ADDENDUM No. 2

ITB No. 4496

West Liberty Reconstruction

PROJECT MANAGEMENT - PUBLIC SERVICES - CITY OF ANN ARBOR
WEST LIBERTY STREET RECONSTRUCTION
S. FIRST ST. - N. MAIN ST.
 LIBERTY ST. WATER MAIN PLAN AND PROFILE
 STA. 4+00 TO STA. 7+00

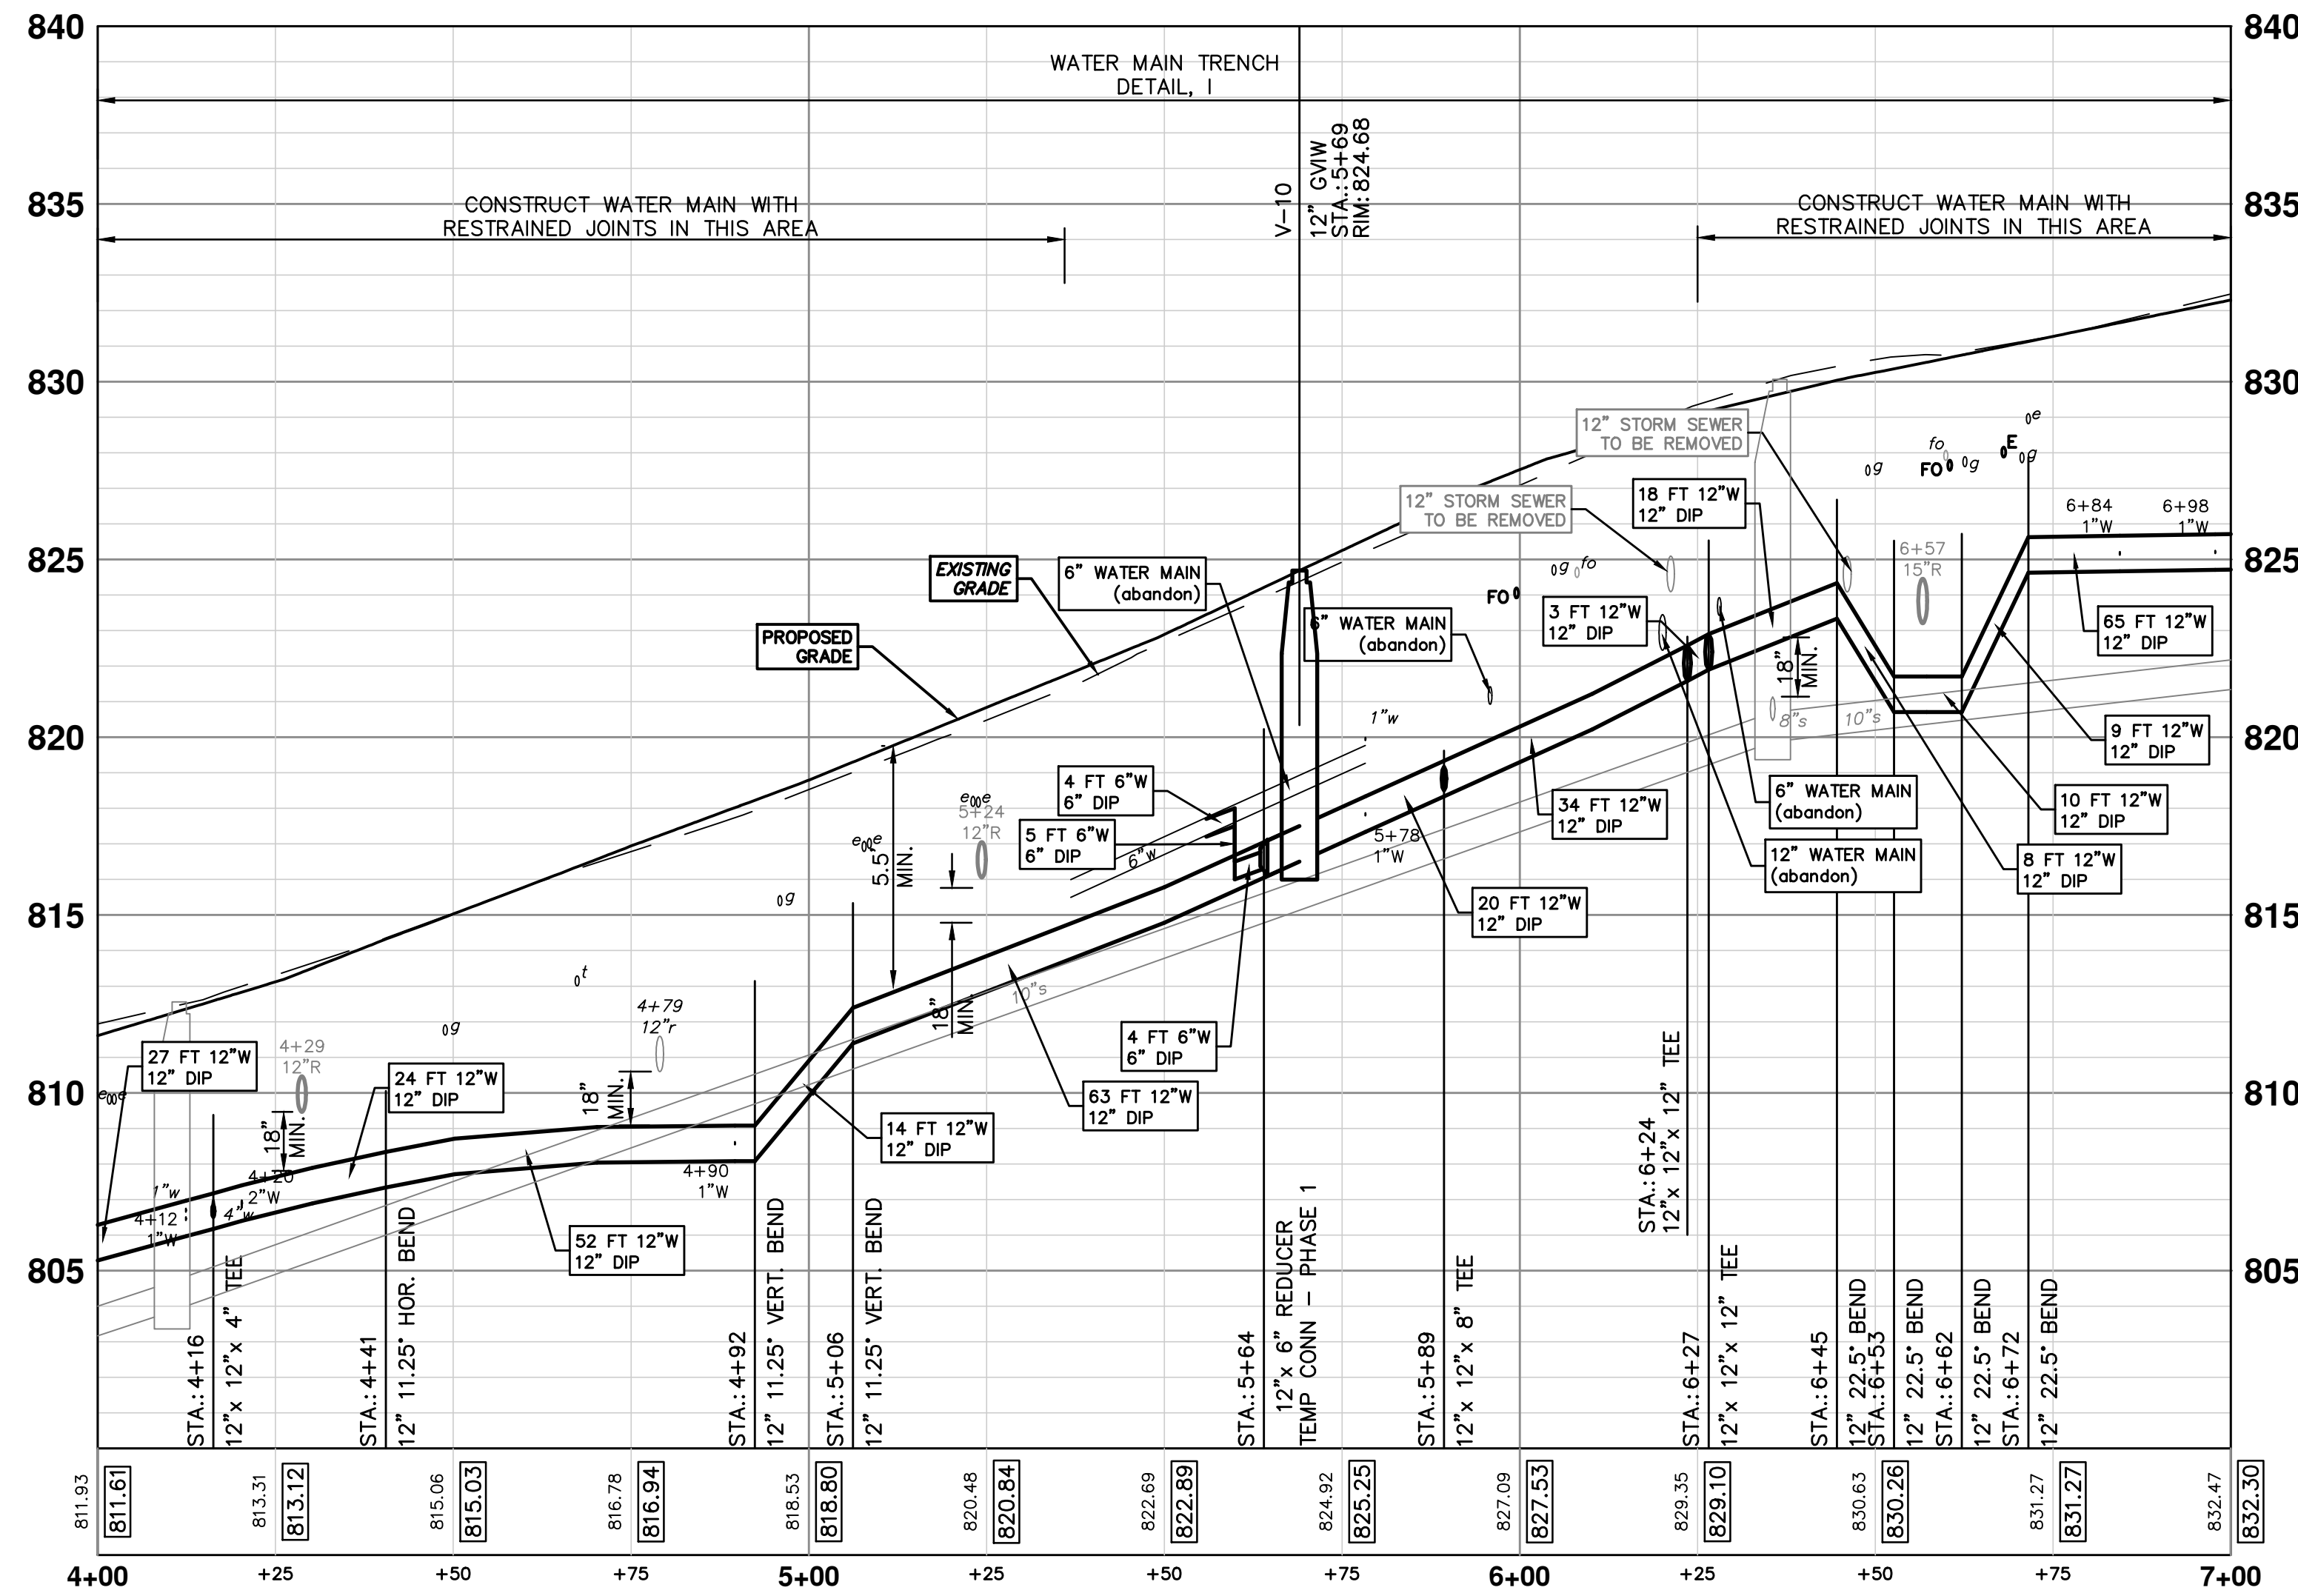
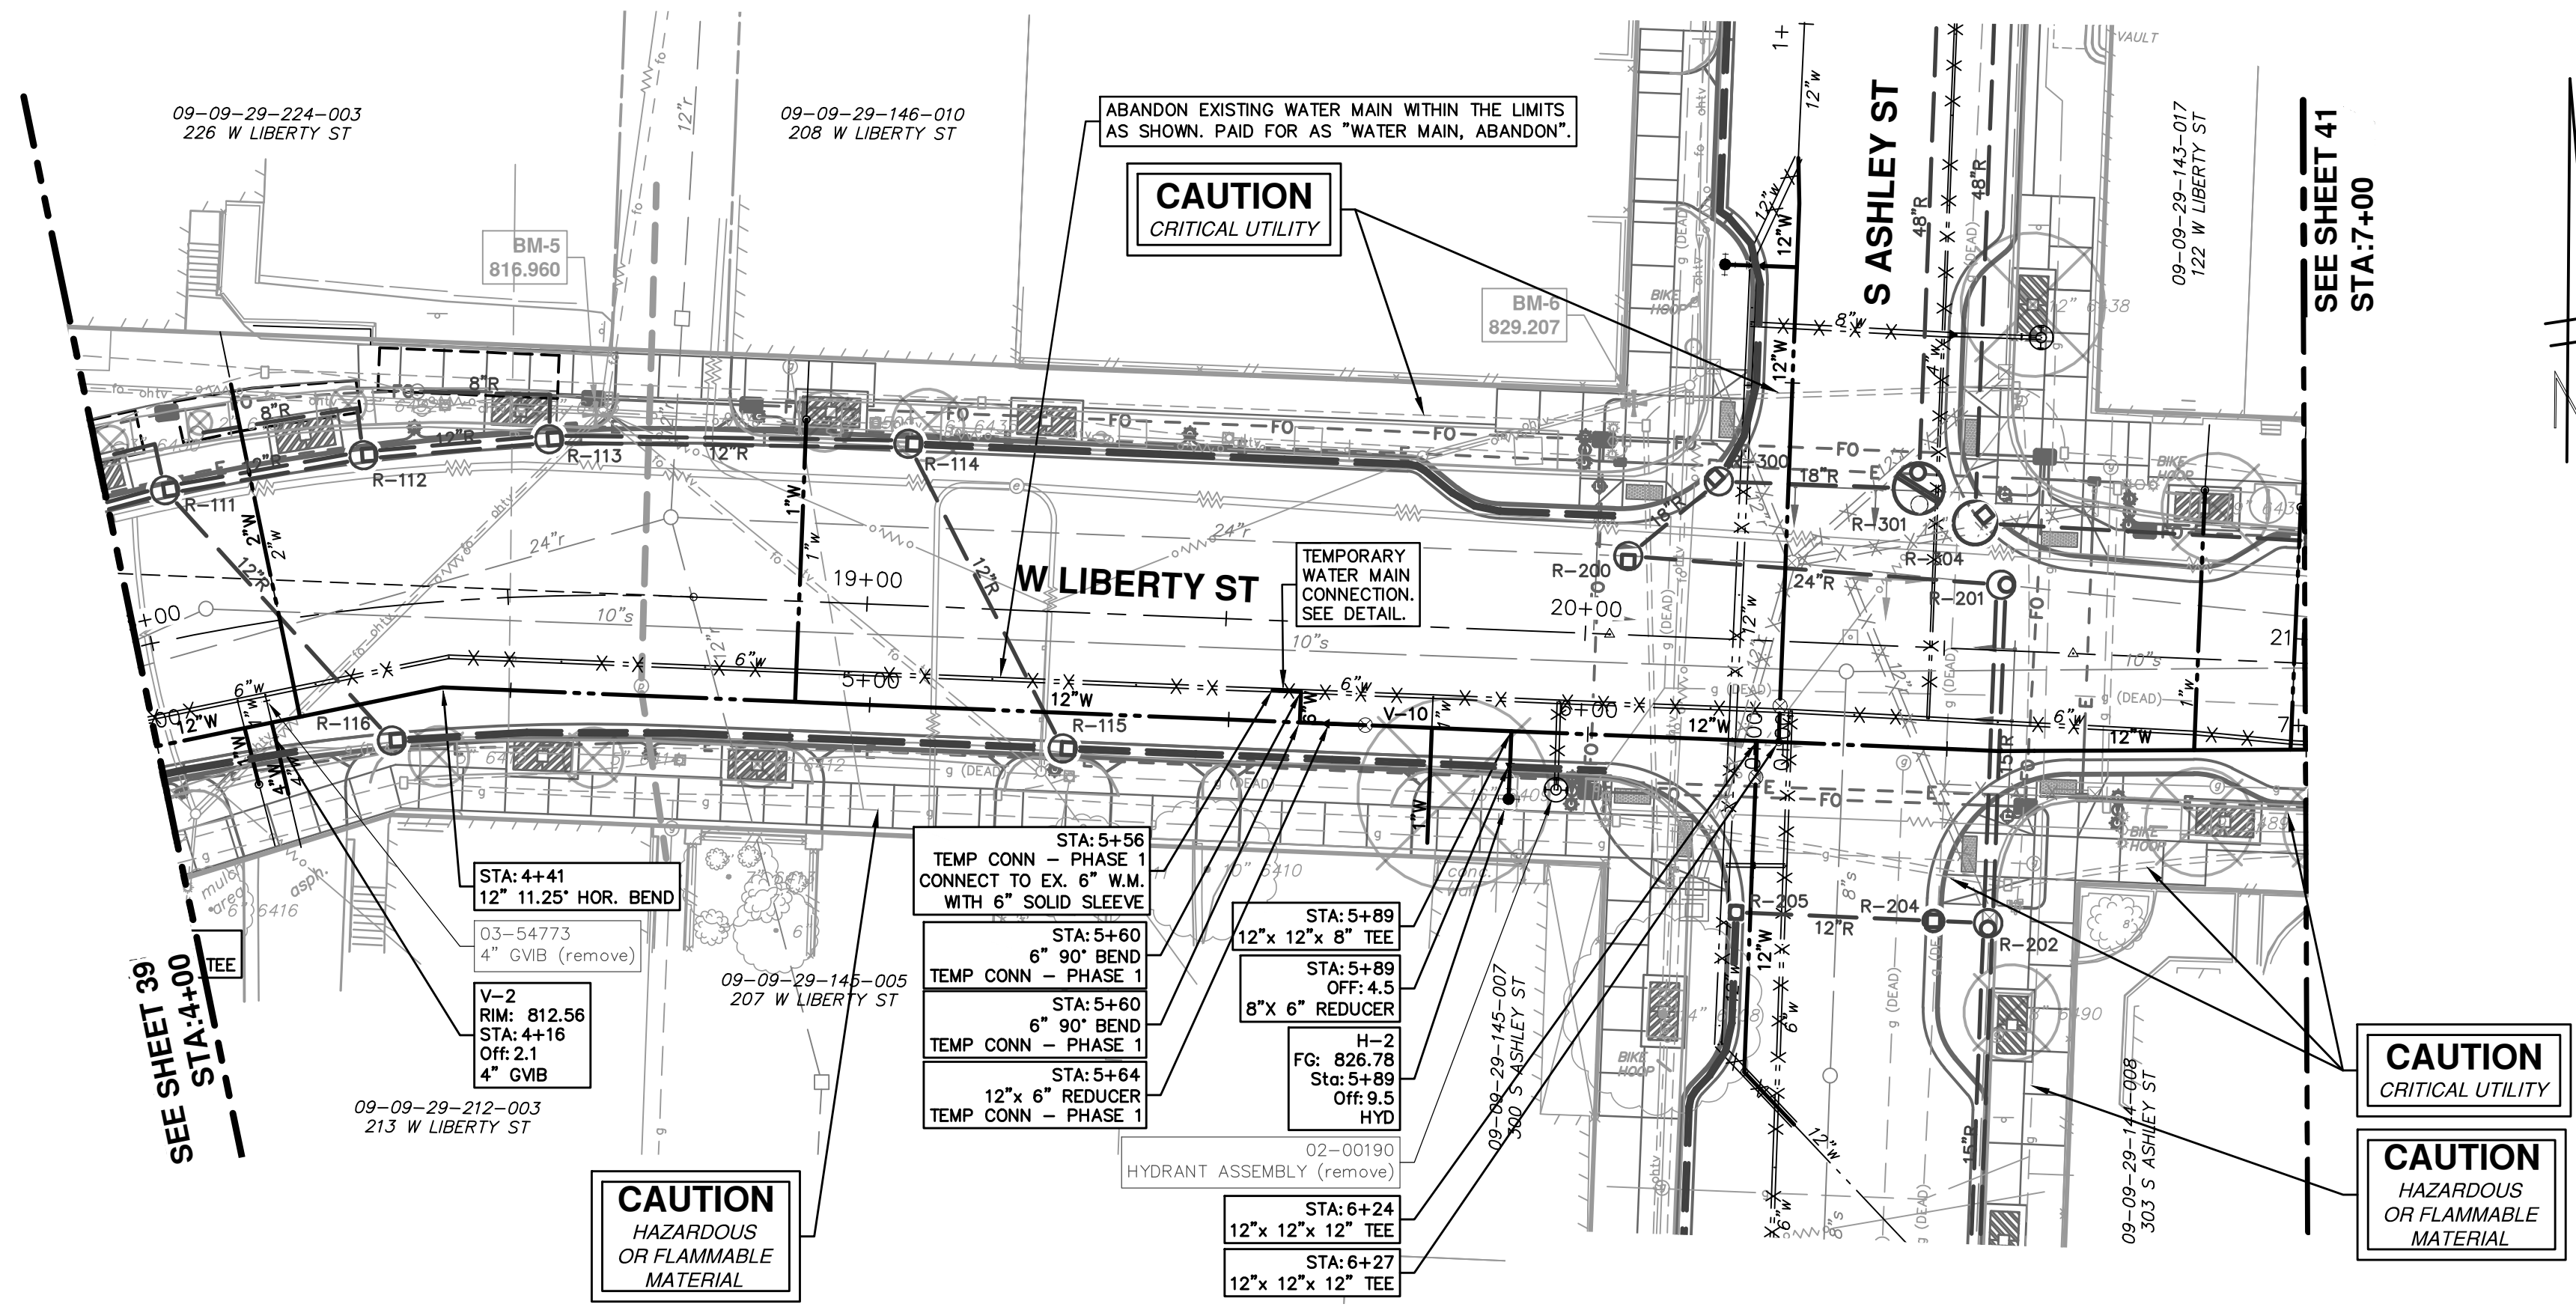
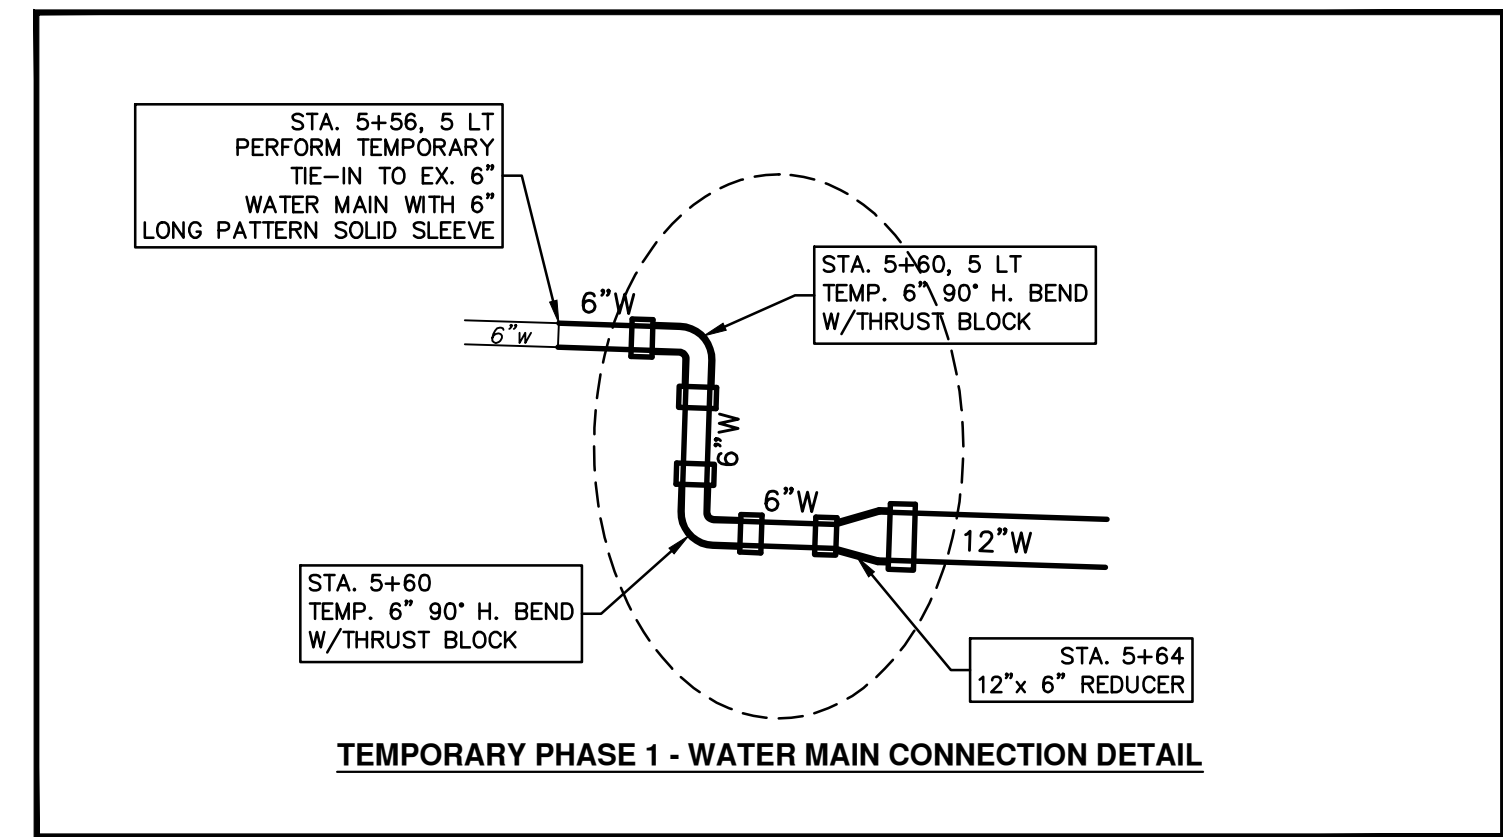
- Pg 8 – Infiltration Trench detail revised.
- Pg 37 – Trench backfill detail revised to IA.
- Pg 40 – Temporary water main interconnect between phases has been added.
